PLANNING DIRECTOR'S SPECIAL PERMIT
 1231 "I" STREET, SUITE 200, SACRAMENTO, CA 95814

- APPLICATION:**
- A. Negative Declaration
 - B. Planning Director's Special Permit for a Deep Lot Development consisting of two single family homes on one parcel totaling 1.0± acres in the Standard Single Family (R-1) zone.

LOCATION: 5640 71st Street

PROPOSAL: The applicant is requesting the necessary entitlements to construct two single family residences on a deep lot.

FRONT ELEVATION
SCALE 3/8" = 1'-0"

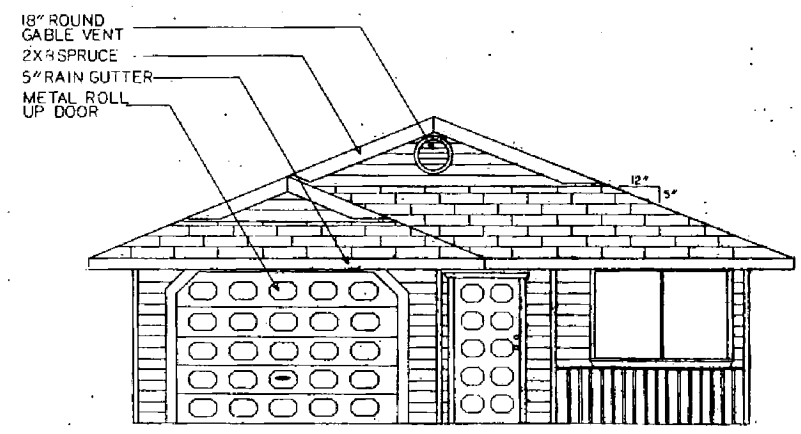
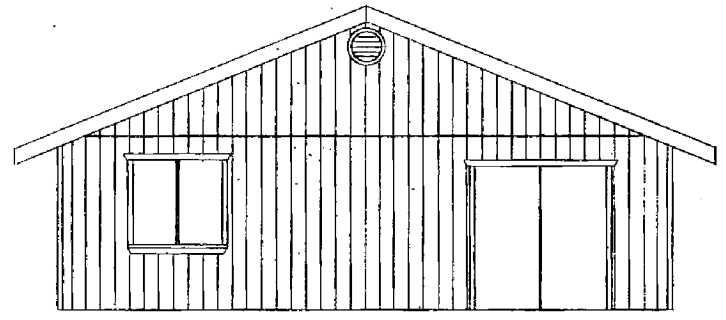
The elevations indicate the exterior building materials to consist of lap siding and T1-11, with the roof material as composition shingles. Staff has reviewed the design with a member of the Design Review staff and suggests revised elevations be submitted for the review and approval of Design Review staff. The revised elevations should include a pair of single hung windows with heavy trim on the front elevation, and for the window on the side of the garage. The applicant should provide the 8" horizontal lap siding as shown on the elevations with the T1-11 on the sides and rear. The T1-11 should have a base and corner trim. The roof material should be laminated dimensional composition with a minimum of 25 year rating as indicated on the submitted plans. The applicant should also work with Design Review to include design features which the two units appear different, as well as the location of any yard area fencing.

- 1. The applicant shall landscape and irrigate the front yards of the units. The landscaping shall consist of, at a minimum, sod with a tree in front of each unit.
- 2. The applicant shall submit revised elevations for the review and approval of Design Review staff. The elevations should include a pair of single hung windows with heavy trim on the front elevation, and for the window on the side of the garage. The applicant should provide the 8" horizontal lap siding as shown on the elevations with the T1-11 on the sides and rear. The T1-11 should have a base and corner trim. The roof material should be laminated dimensional composition with a minimum of 25 year rating as indicated on the submitted plans. The applicant should also work with Design Review to include design features which make the two units appear different, as well as any yard area fencing.

98' 71st STREET

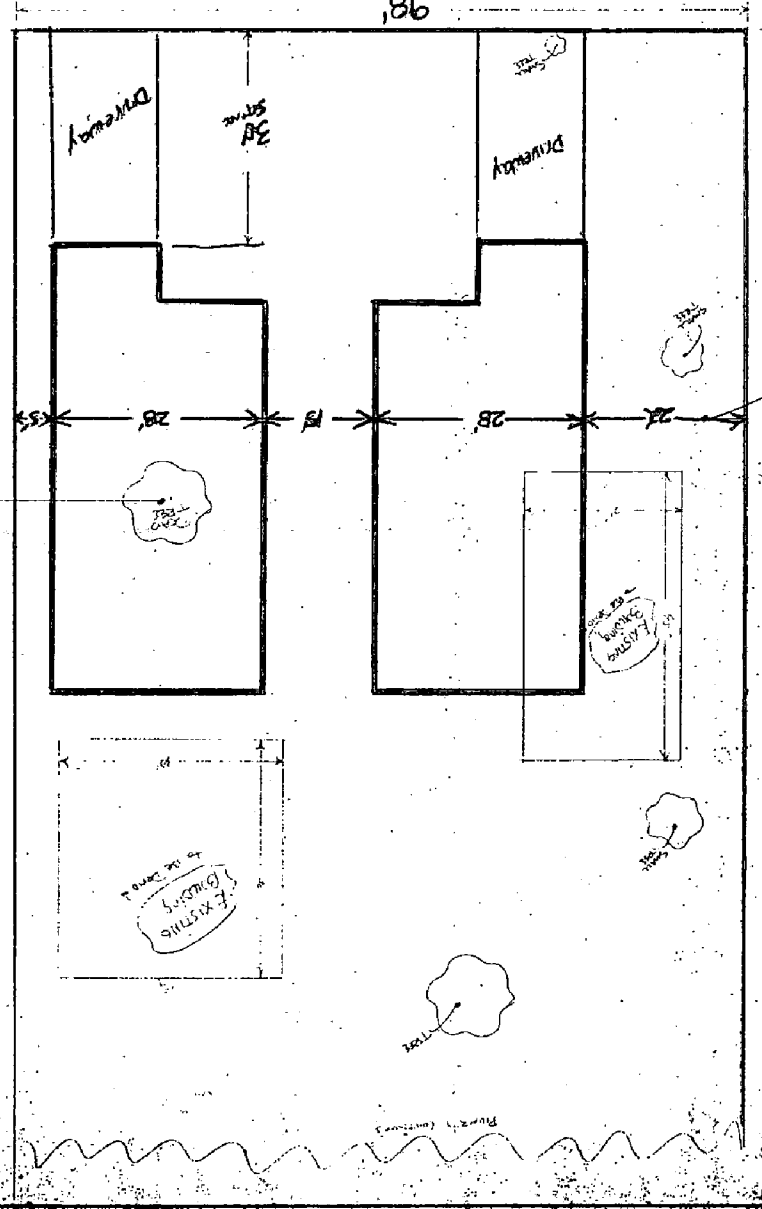
The applicant should landscape and irrigate the front yards of the units. The landscaping should consist of sod with a tree in front of each unit.

- 1. The following trees shall be saved:
 - o 13" Black Locust located on the southeast portion of the lot
 - o 11" and 11" codominant Mulberry located on the southwest portion of the lot.
- 2. The saved trees (13" Black Locust, 11" and 11" codominant Mulberry) shall have a six foot high construction barrier installed around the dripline of each tree prior to the commencement of grading on site. This not shall be included on the grading and/or site plans submitted for building permits.
- 3. No surface or grade changes, no trenching, no parking of vehicles, and no storage of materials shall take place within the fenced in areas around the driplines of trees to be preserved.
